SUBJECT: Forwards response to questions re proposed Tech Spec change, per 841003 request. Core operating limit supervisory sys used to monitor DNB & local power density limiting conditions for operations.

Subject: Docket Nos. 50-361 and 50-362
San Onofre Nuclear Generating Station
Units 2 and 3

RESPONSE TO NRC QUESTIONS ON
PROPOSED TECHNICAL SPECIFICATION CHANGE NPF-10/15-138

FIGURE 1

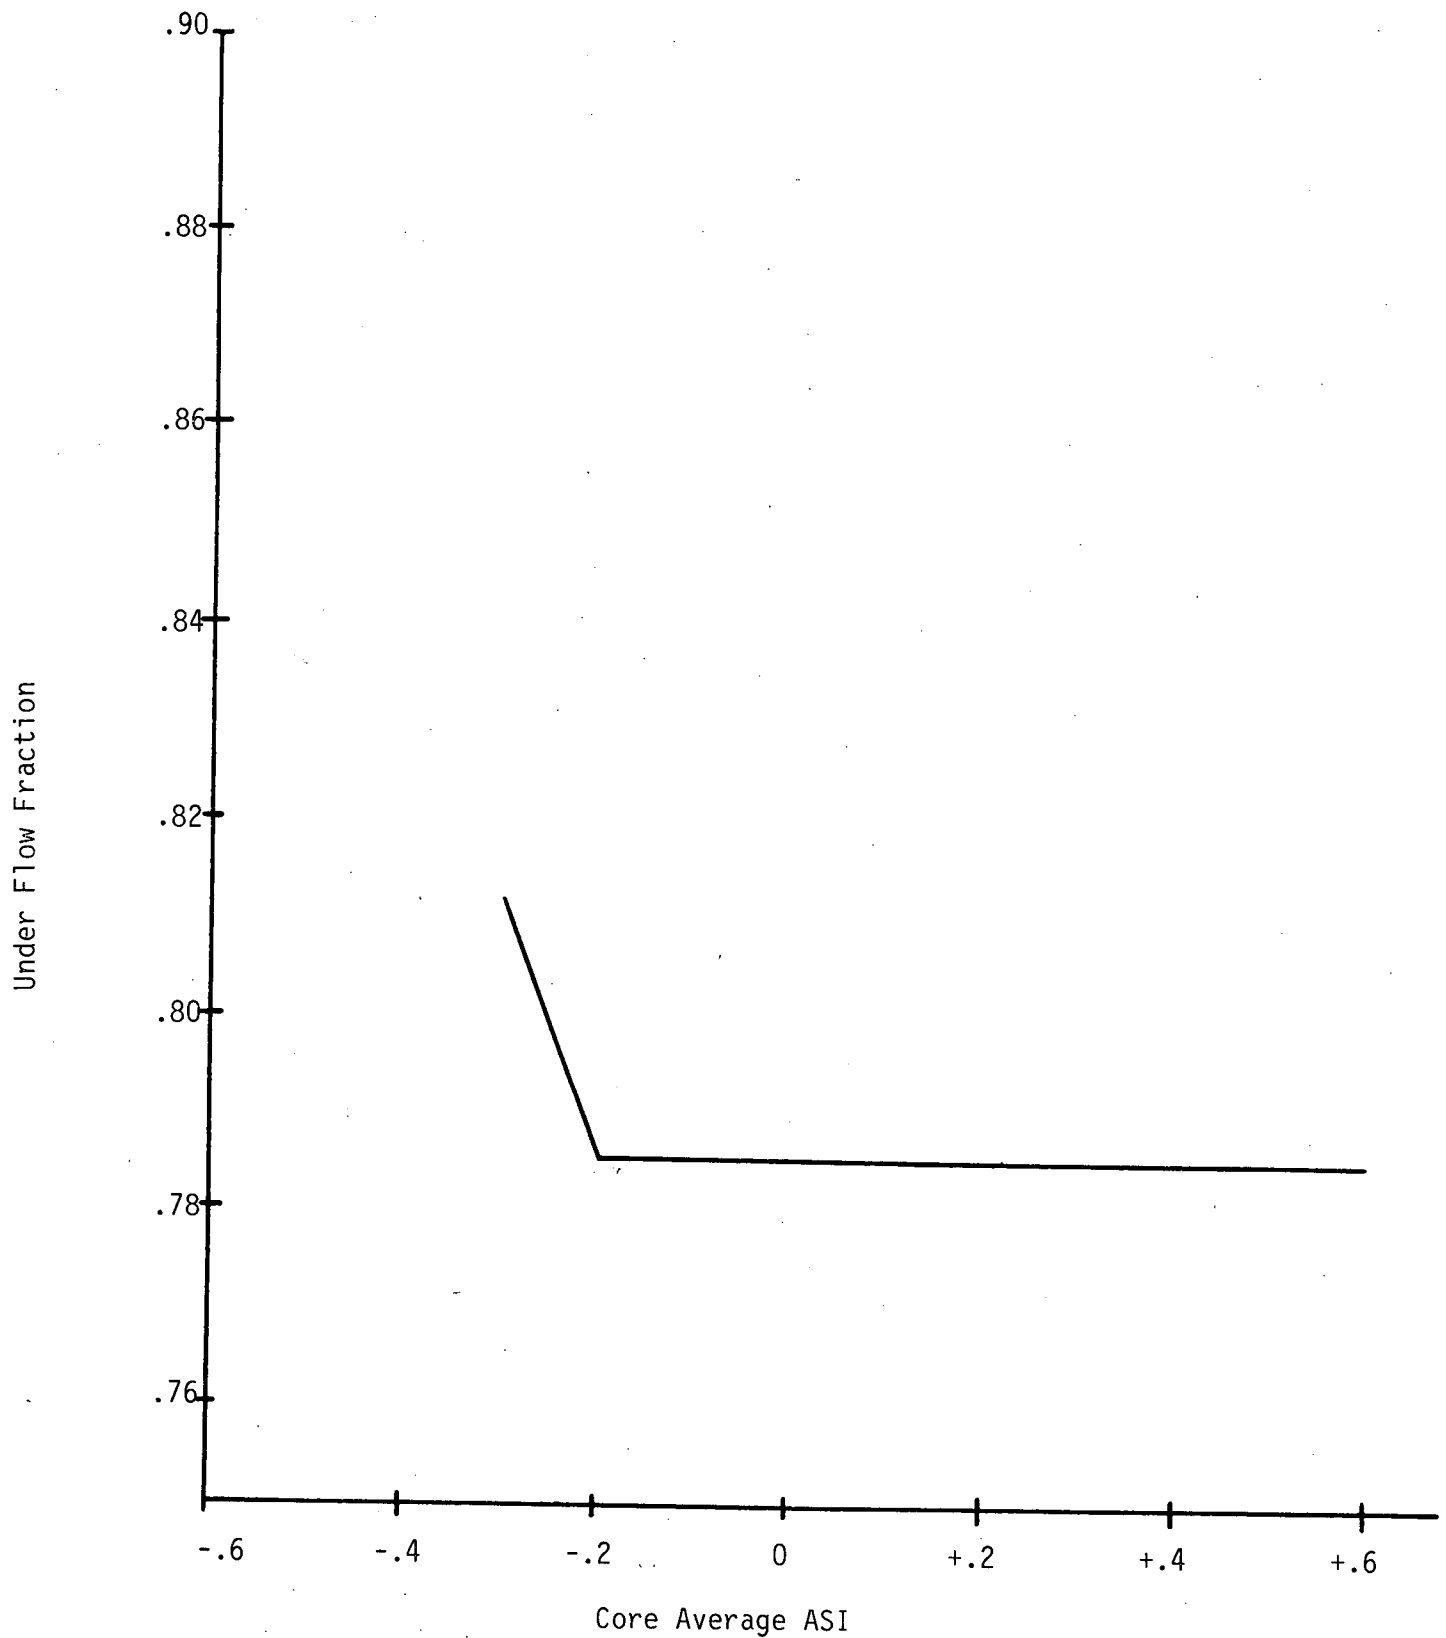
Question 1:

Provide the analysis, or reference any document that has been submitted to the NRC for the determination of the ROPM in COLSS. What are the values of the ROPM for San Onofre Units 2 and 3?

The COLSS is used to monitor the DNB and LPD limiting conditions for operation. The system preserves sufficient margin in terms of core flow (i.e., biasing the steady state flow by a multiplier) to the DNB SAFDL so that DNB would not occur during any AOO. The four pump loss of flow event is the most limiting such event and determines the minimum required margin. This margin is equivalent to a penalty multiplier on core power of at least 1.14, although more margin is reserved at most conditions. This is referred to as the ROPM for SONGS Units 2 and 3. The core flow multiplier (Under Flow Fraction) curve for San Onofre Units 2 and 3 are shown in Figure 1.
